Product Change Notice (PCN)

PCN Number: **PCN-0457142R-01**

Product(s) Affected: *PJ-118-X7*

PREVIOUS SAME SKY DETAIL / IMAGE	NEW SAME SKY DETAIL / IMAGE

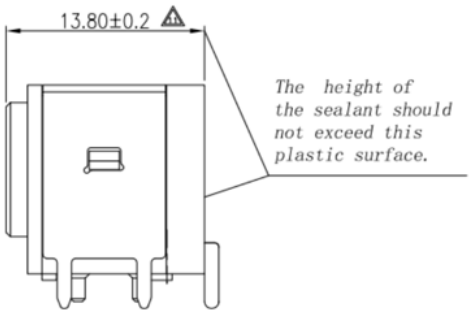
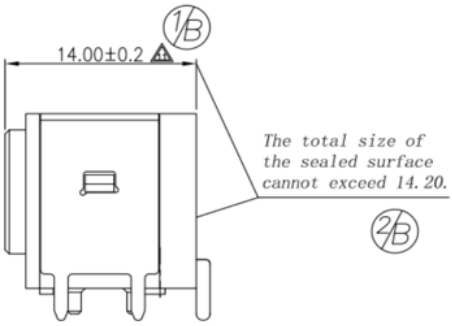
Reason(s) for Change: *To ensure waterproof sealing performance by increasing the sealing surface. Current adhesive used is thick and difficult to control*

Description of Change: *Increase in product length from 13.80 to 14.0*
